# 461 CHAPEL ROAD

BANKSTOWN 2200

DESIGN REVIEW REPORT

07 / 04 / 2025

WEDDING MODE ~90 seats & 9 tables, ~8-seat-bridal-table, dance floor etc.

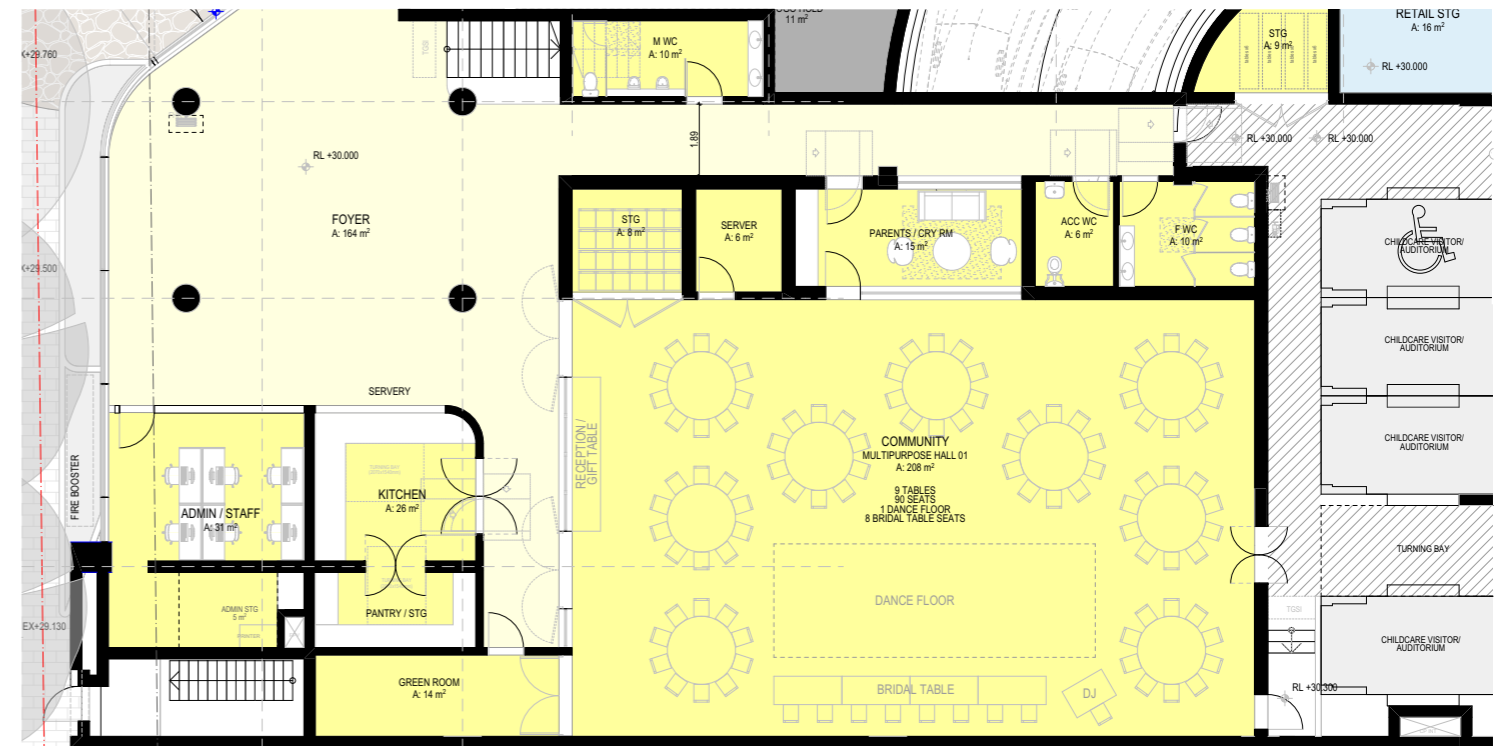
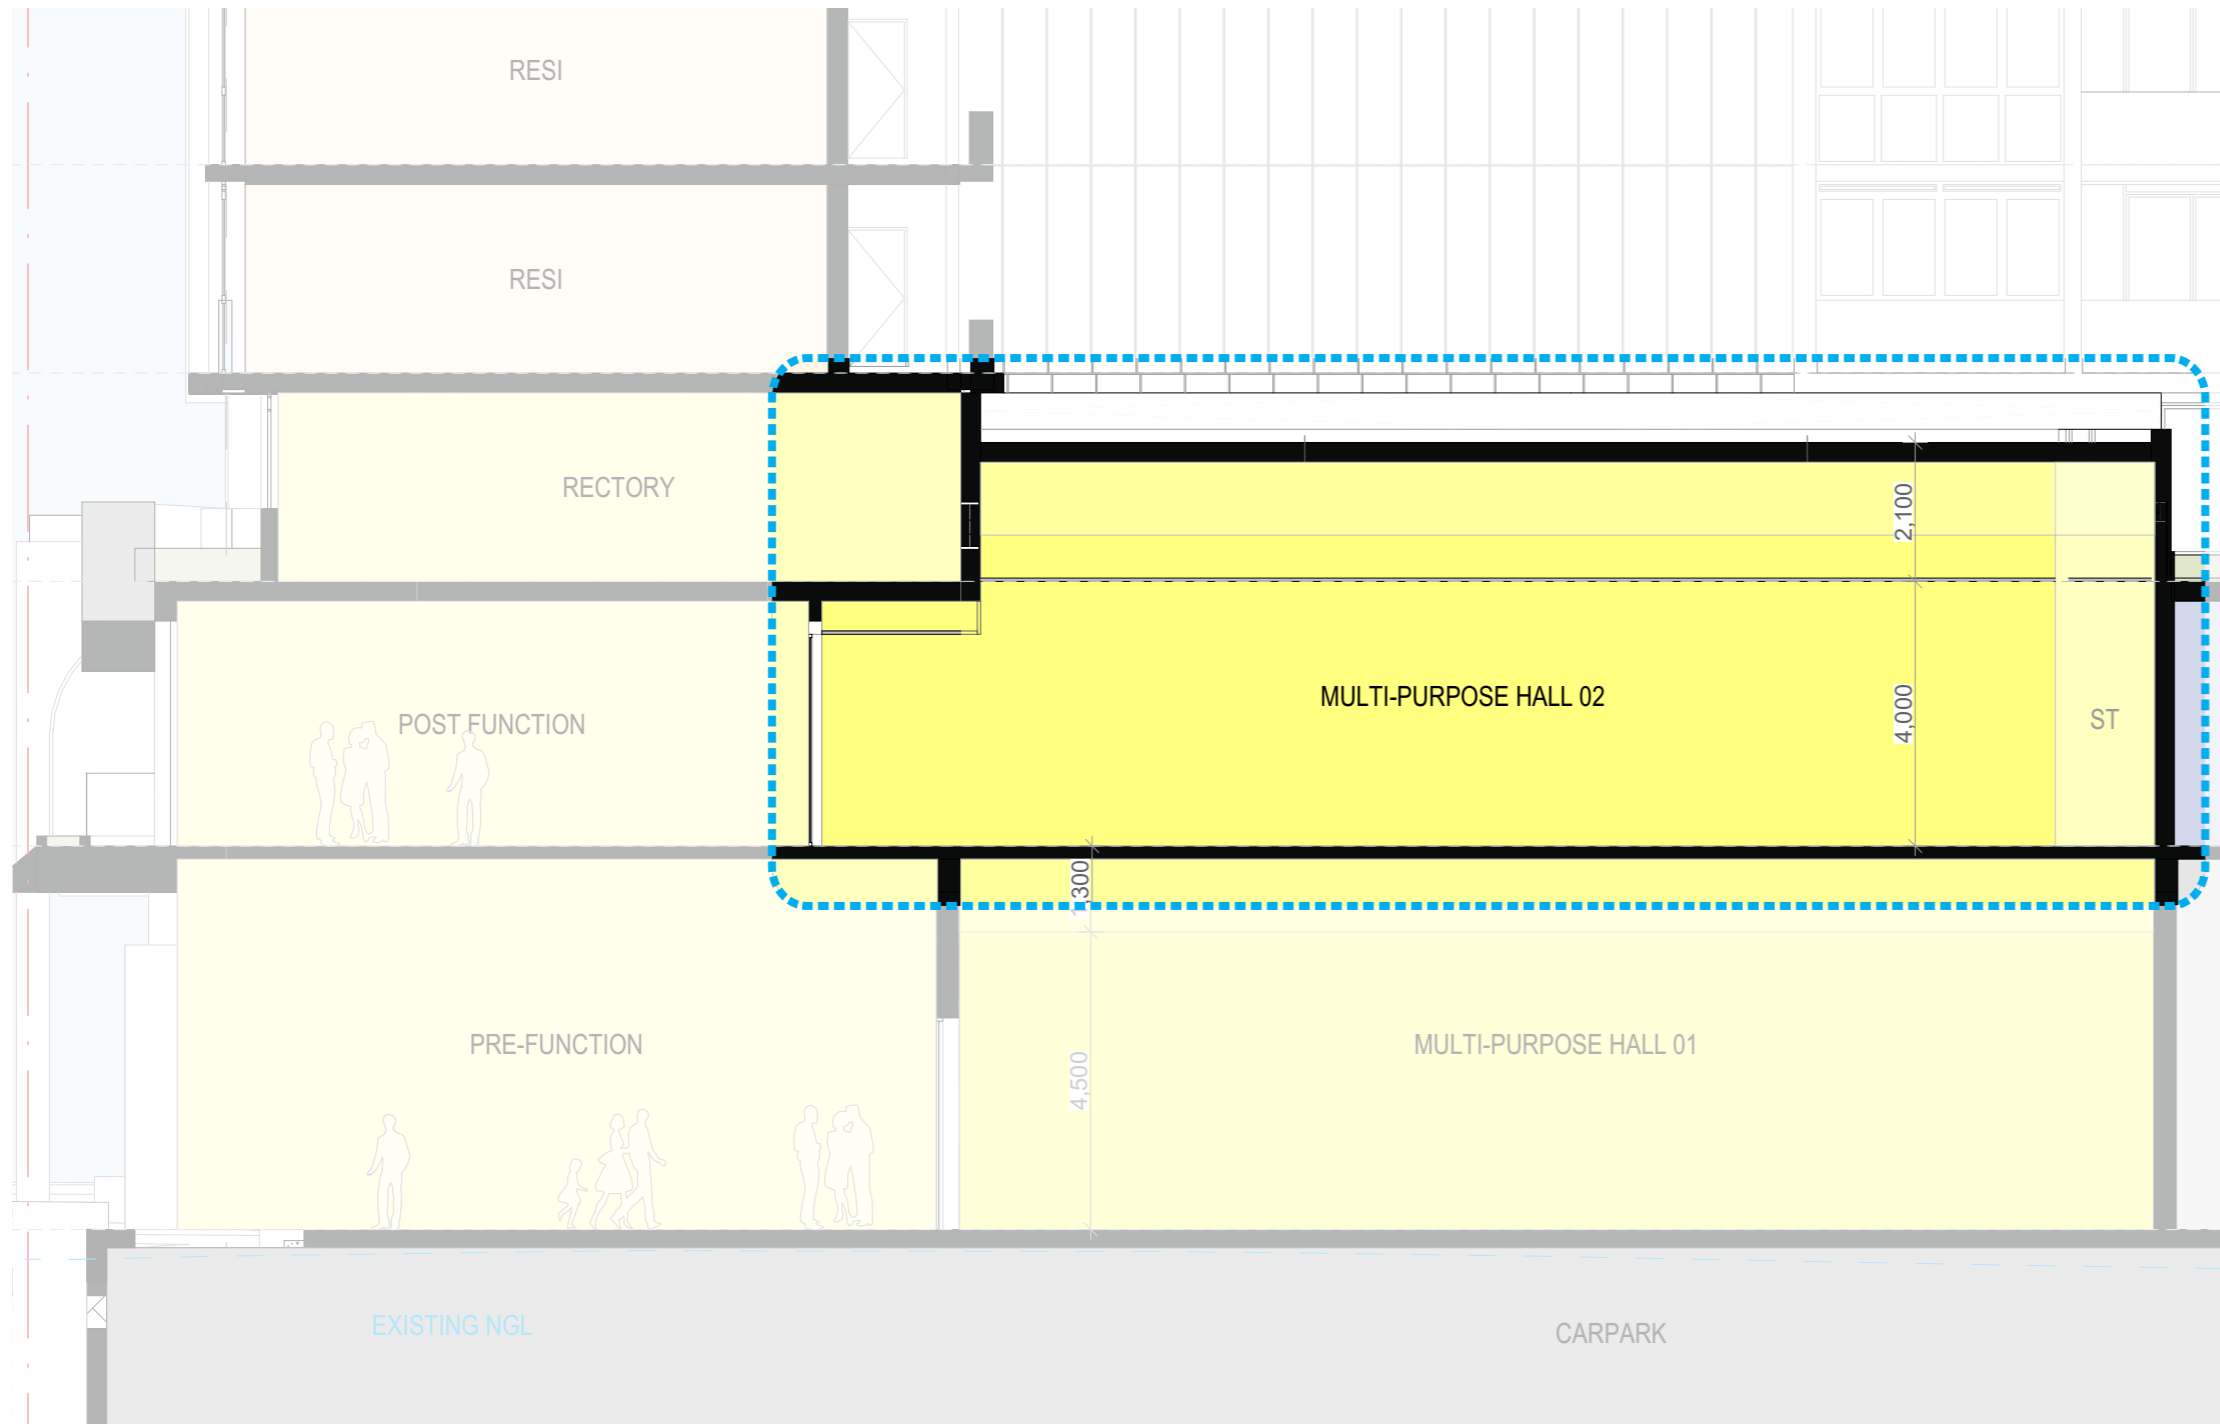
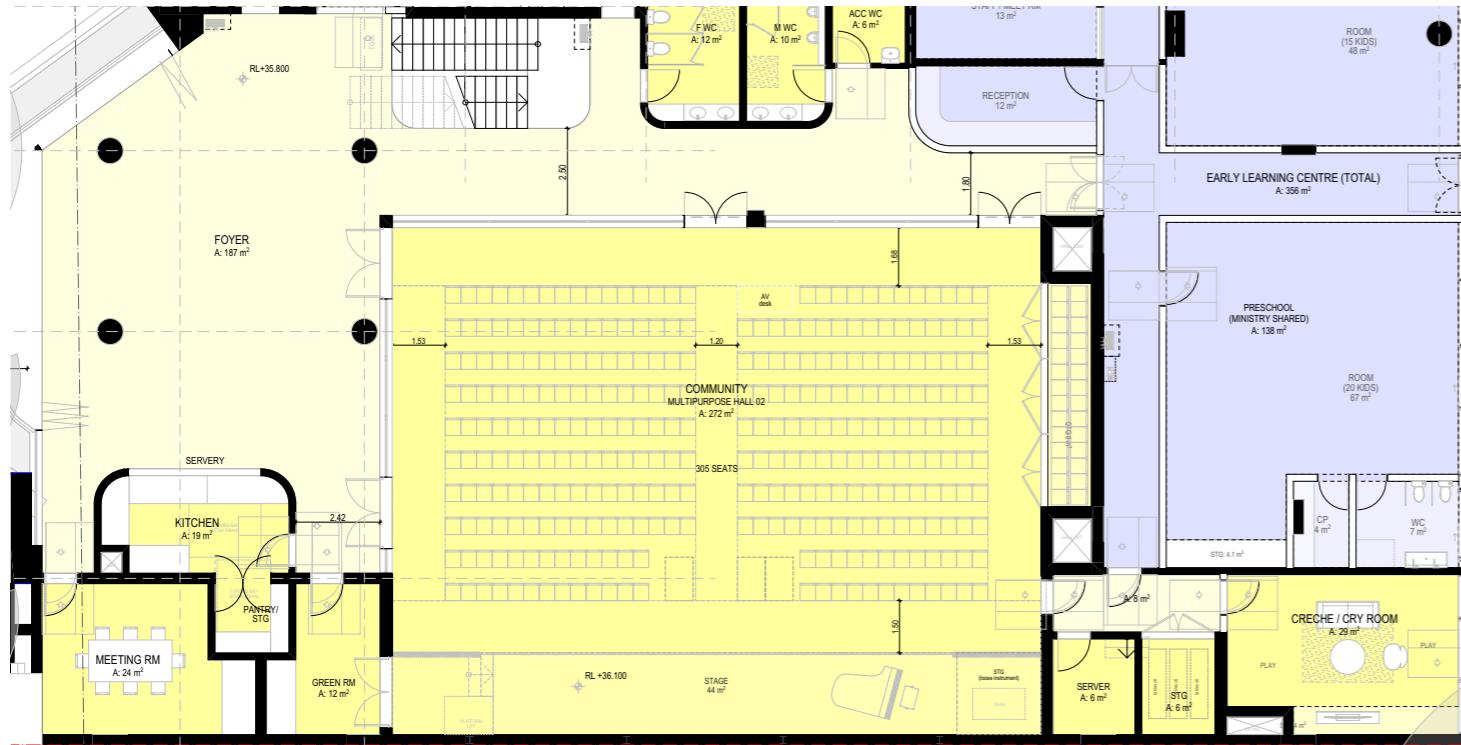
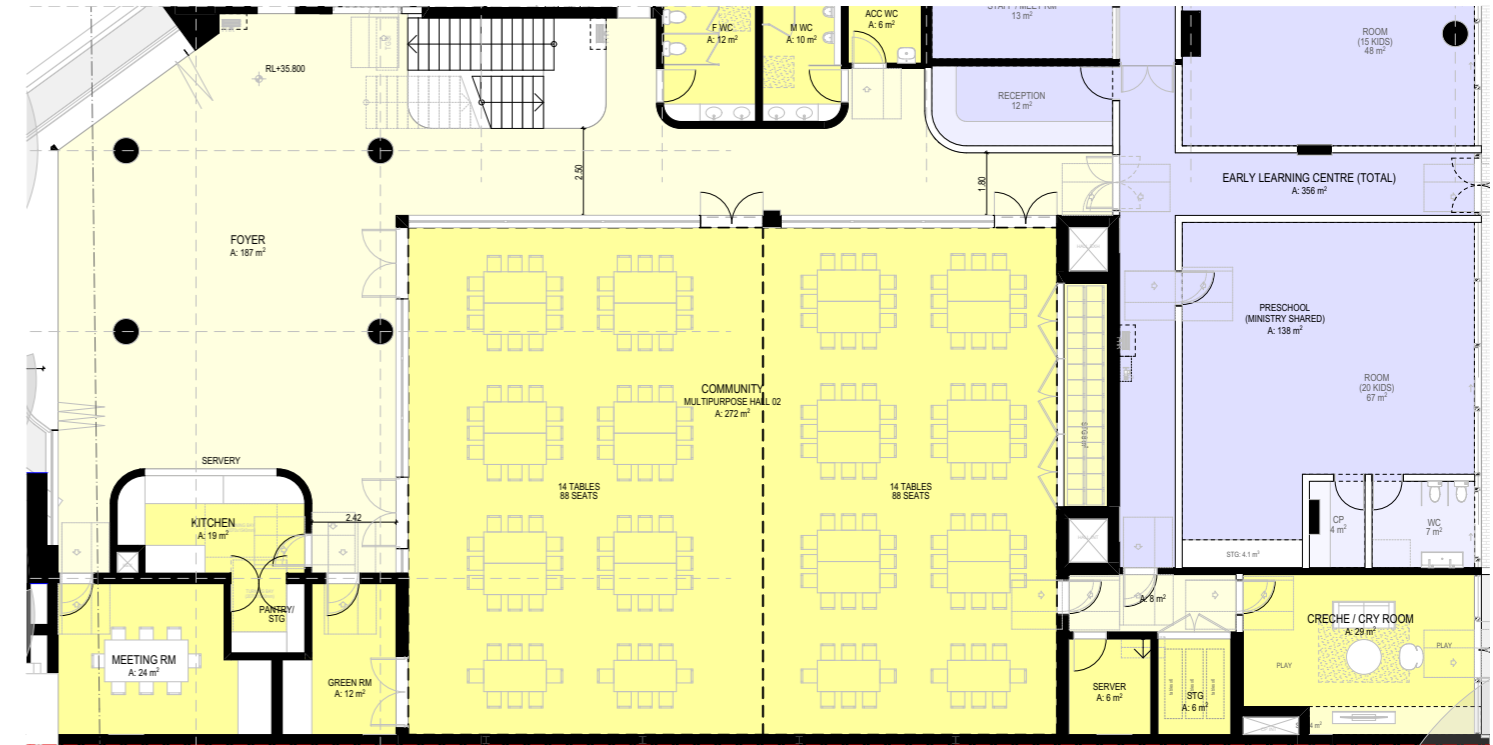
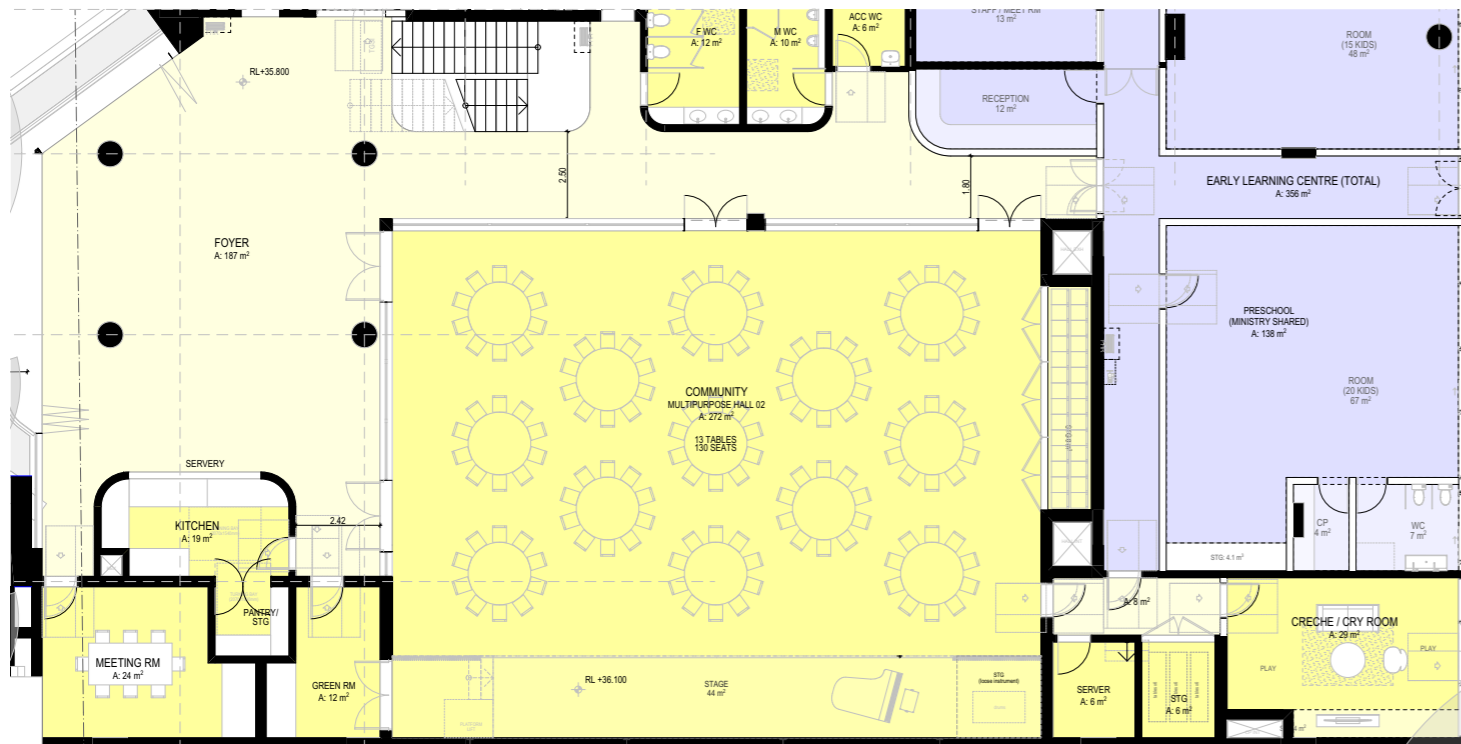
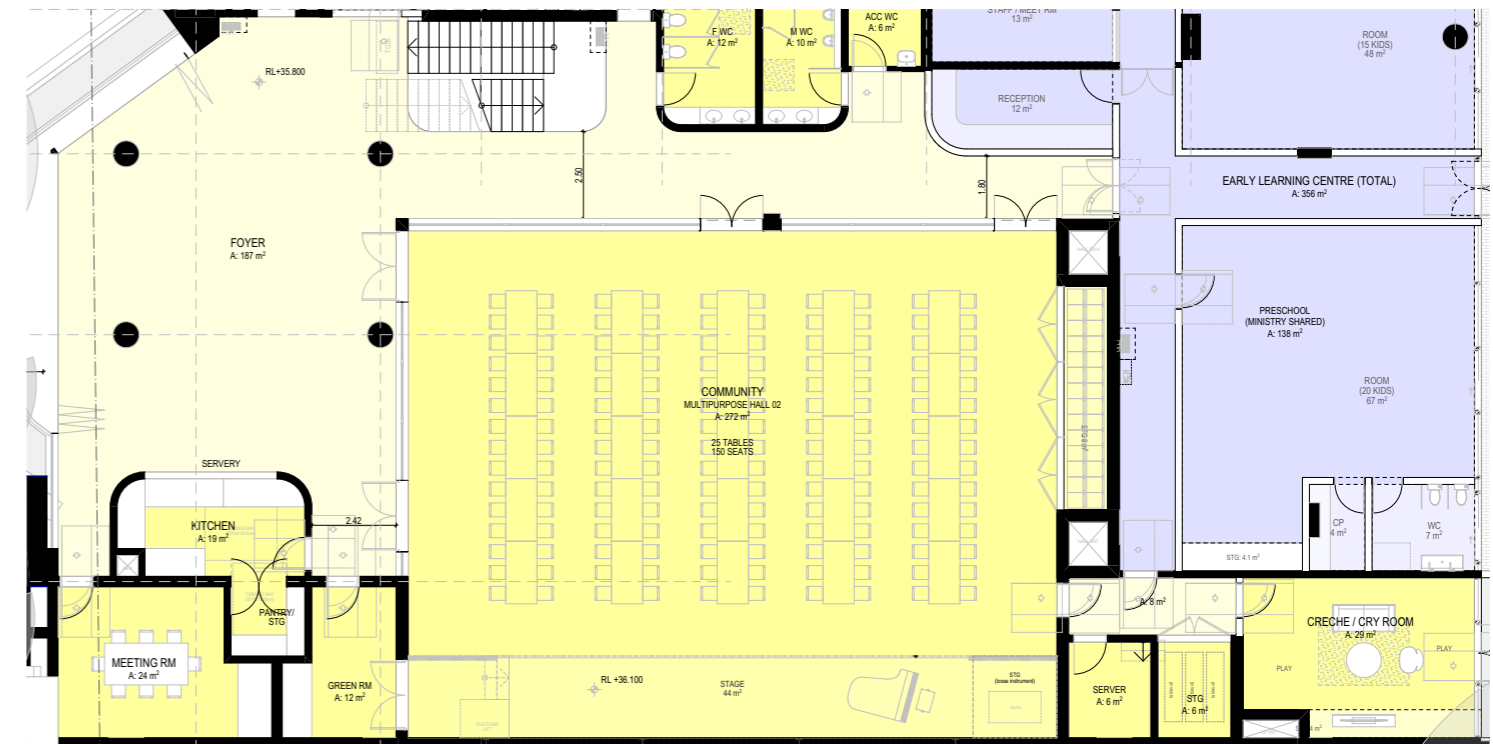
Providing two distinct multipurpose spaces offers great flexibility and opportunities to activate the project for community benefit.

a. Confirm the dimensions of each space and identify what functions can be accommodated. Seek opportunities to support community programs and business

b. Clarify hours of use and identify potential impacts on adjacent uses e.g. residential, childcare, parking and church functions.

- The dimensions of the ground floor community facility are 18.05m x 11.58m
- The dimensions of the Level 1 community facility are 18.65m x 14.58m

a. The ground floor community facility will accommodate various activities including a variety of indoor recreation uses that support the physical wellbeing of the community, such as dancing, gymnastics, pickleball, table tennis and more, whilst also being appropriate to support other community wellbeing programs, such as Alcoholics Anonymous.

b. An Operational Management Plan has been prepared for the Community facility and outlines how impacts between adjacent uses will be managed. This is detailed within Section 4.6.2 of the EIS.

### ITEM 03.05 - HIGH QUALITY MATERIALS

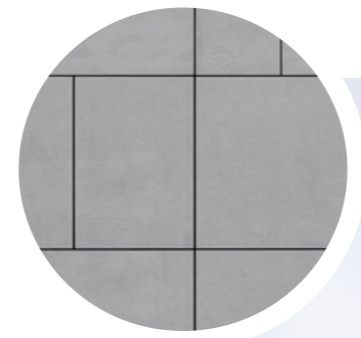
Select high quality materials with integral colours and/or textures to ensure long-term durability and low maintenance.

The proposed development utilises high quality materials and textures that prioritise long-term durability and low maintenance.

The podium and north-west corner comprise brickwork which require minimal maintenance whilst the additional site has a different material finish, with coloured pre-finish panels. This will enhance the design quality and increase the durability of the site.

**01.06 CHARACTER & MATERIALS**

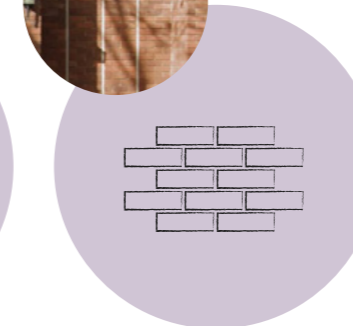
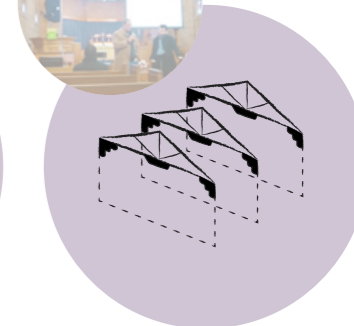
01.06 Council's DCP has character controls for this precinct – particularly in relation to materials and Church architecture, the spire etc. Refer to Section 2 - Understanding Place, 2.1 Character areas Chapter 6.2 Bankstown City Centre in Council's DCP , in particular, the extracted section below.

**P9. The design of new development at St Paul's Anglican Church should maximise the use of existing building fabric, such as stained glass windows, masonry and the iconic bell-tower/spire design to Chapel Road. Surrounding development should be complimentary and include landscaping and materiality that complements the Church building.**

Existing church characters have been considered in the design of the proposed building.

- *Iconic bell-tower/spire design to Chapel Road*
- *Vertical rhythm & proportions*
- *Masonry / brick materiality*

As an overall gesture at the macro scale, the podium and the tower corner are expressed as the ecclesiastical component of the building. The tower corner, in particular, is inspired by the bell tower / spire of the existing church, and is interpreted as a tall element that marks the intersection as a strong urban gesture, with a subtly expressed Christian cross, inspiring all in view of the tower.

This has been achieved by the use of brick materiality as a continuation of the bricks used in the existing church; as well as the vertically slender proportions of frames and openings to honour the vertical rhythm & proportions of the existing building characters.

- *Stained glass windows / window frames*
- *Pews*
- *Timber beams / trusses*
